Stage 04: Code Administrator Consultation

Grid Code

GC0100 EU Connection Codes GB Implementation – Mod 1

This modification will set out within the Grid Code the following compliance obligations in the EU Connection Codes:

Figure 3.15(b) – GB Proposed Voltage Against Time Curve of a Type B, C or D Power Park Module connected below 110kV showing the conflict with Stage 2 G59 Undervoltage Protection

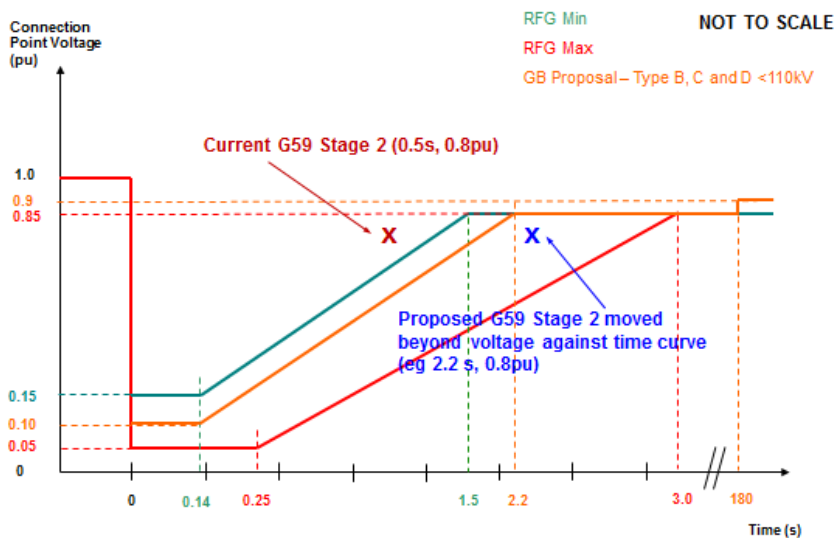
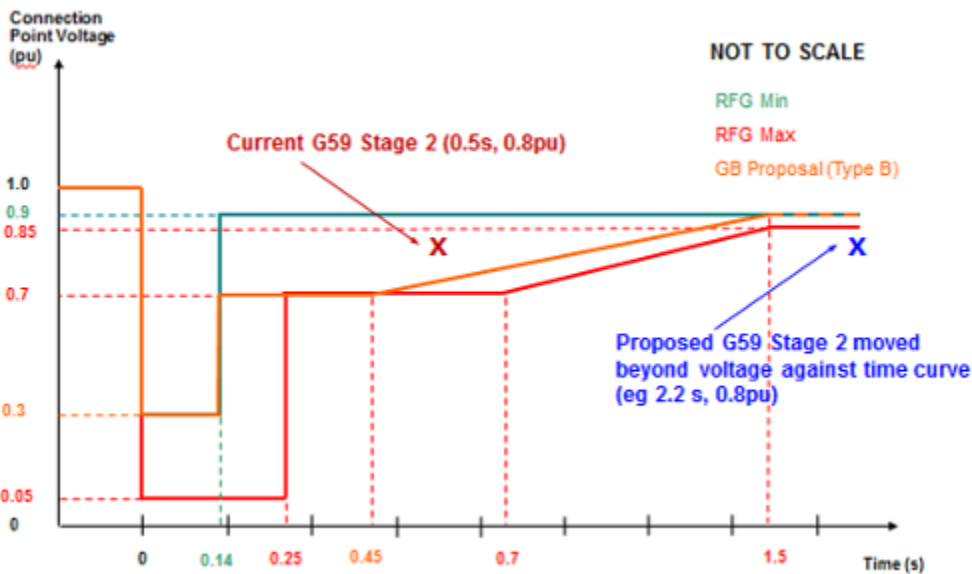
The proposed voltage against time curves for Type B – D Power Generating Modules are detailed above. For those Power Generating Modules which are connected to the Distribution Network, stakeholders noted that there would be a conflict with the G59 under voltage Stage 2 protection which is currently set at 0.8pu for 500ms. Whilst this was marginal in the case of the voltage against time curve for Synchronous Power Generating Modules it was more severe in the case of Power Park Modules where even the minimum RfG voltage against time criteria would have been incompatible with the current G59 Stage 2 under-voltage protection settings.

These issues are shown in Figures 3.15(a) and 3.15(b).

The Workgroup discussed this and The Proposer decided that the best policy for their original solution would be to move the G59 Stage 2 undervoltage protection to 0.8pu at 2.5s. This requirement would apply to all new connecting plant and would be equally applicable to Synchronous Power Generating Modules and Power Park Modules.

It was not believed that changing the G59 Stage 2 Undervoltage protection would cause a significant problem however it was included as a consultation question. The Grid Code/Distribution Code workgroups GC0035 and GC0079 continue to investigate the issues associated with changing RoCoF protection settings for distribution connected generators and have undertaken a risk assessment of Distribution system protection requirements. The analysis for this has been performed by the University of Strathclyde.

Figure 4.1 (a) Effect of Fast Fault Current Injection Option 2 on clearance time

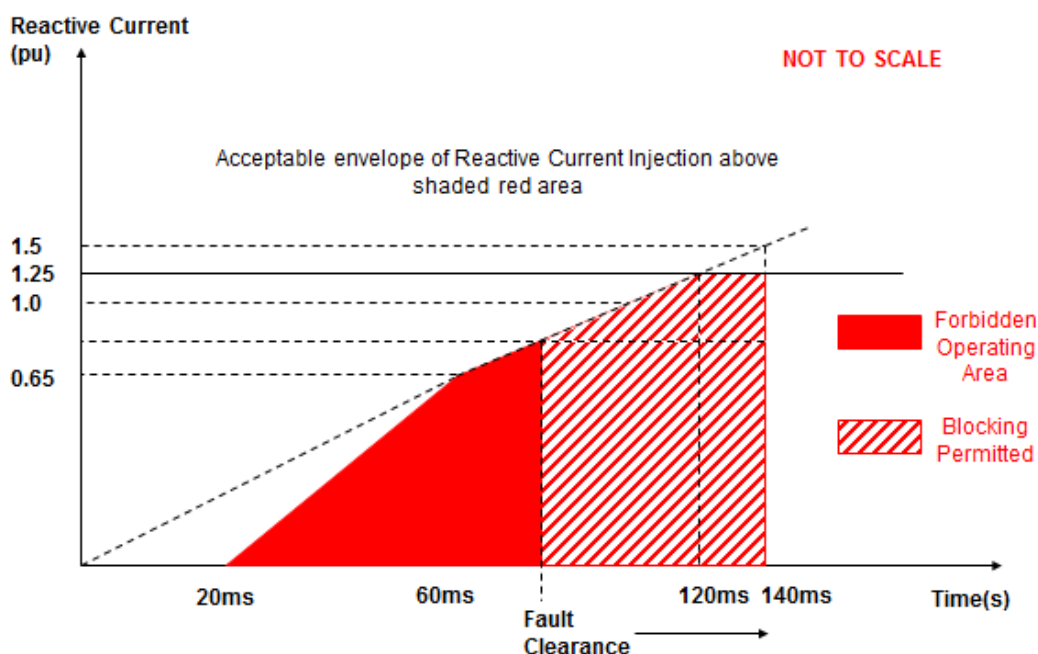
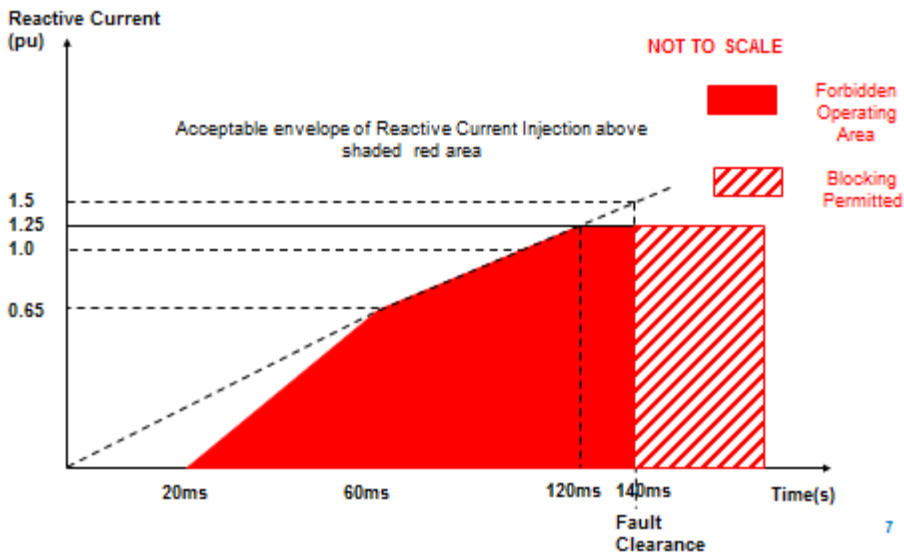
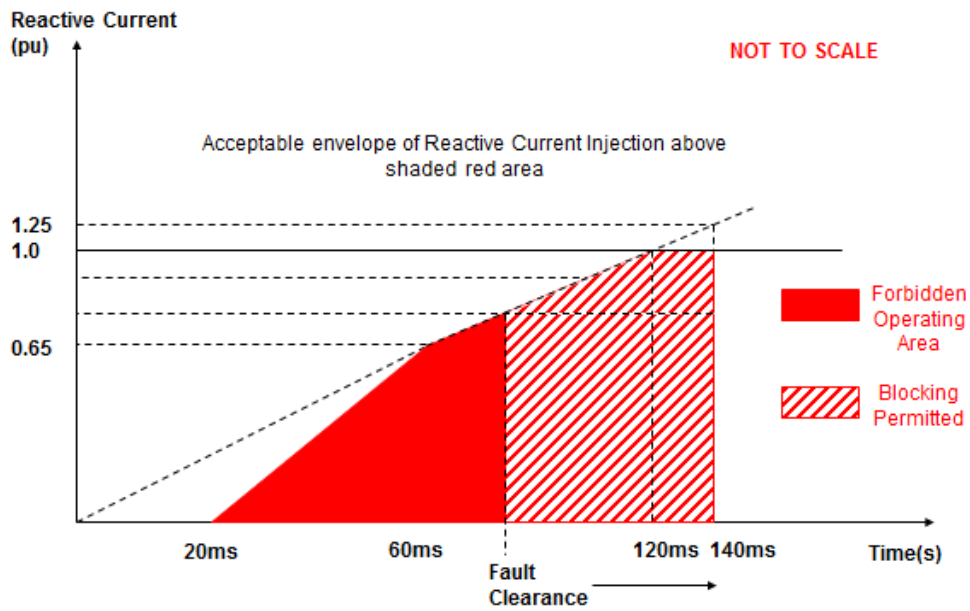
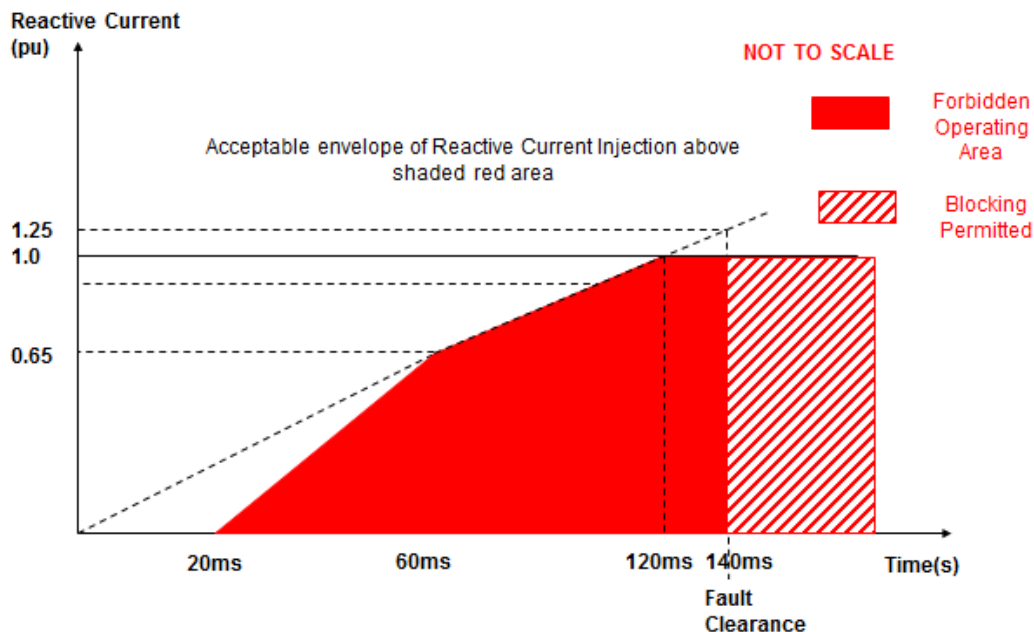
Option 2 requires a minimum volume of reactive current injection as shown in Figure 4.1(a) and (b). Blocking is permitted on fault clearance to prevent the risk of transient overvoltages). This option would apply to all New Type B and above Power Park Modules which had not signed their contract for major plant items by 17 May 2018 or HVDC Owners who had not signed their contract for major plant items by September 2018.

Option 3 is a duplicate of Option 2 above but the maximum ceiling current would be limited to 1.0pu as shown in Figure 4.2(a) and 4.2(b). This option would apply to all New Type B and above Power Park Modules which had not signed their contract for major plant items by 17 May 2018 or HVDC Owners who had not signed their contract for major plant items by September 2018.

Please note that following the Workgroup Consultation the Proposer has clarified that **Option 3** is their proposed solution which is reflected in the legal text in Annex 1.

Figure 4.4 – Extract from Figure 6 of Annex V of the HVDC Code – Voltage against time curve

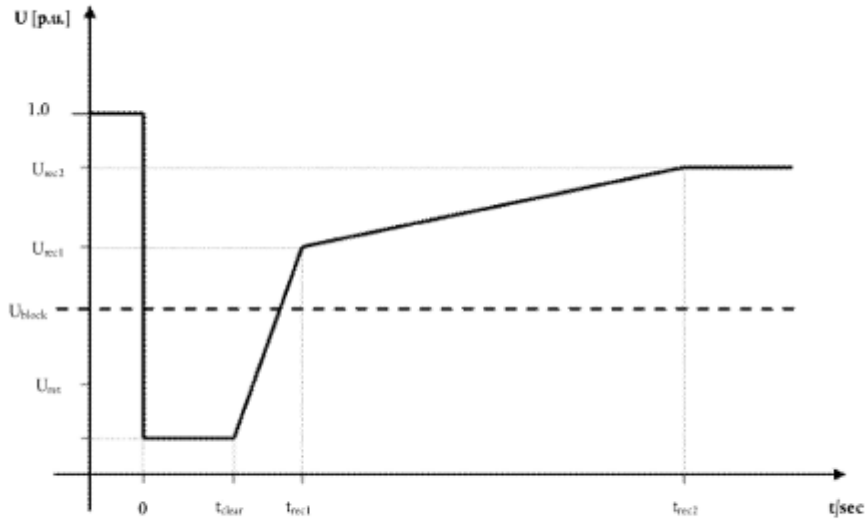
<i>Athanasios Krontiris & Grant McKay, ABB HVDC</i>	The fault ride through curve for HVDC converters in Figure 7.3 is in accordance with the EU network code. However, the fault ride through is not related to fault current injection. Setting Ublock equal to zero practically disqualifies line-commutated converters. During drafting of the EU network code for HVDC, great care was taken to avoid such general disqualifications and we suggest that this may be reconsidered. We would like to further highlight that the instance of fault clearance needs a clear definition. The requirements for FRT and subsequent active power recovery up to 90% within 500 ms from fault clearance must be related to the instance the voltage returns in the 0.9-1.1 pu band. Otherwise significant overrating of the converter is necessary. Note that the term "fault clearance" is also used in Figures 4.4 and in section 4.4, however with another interpretation.
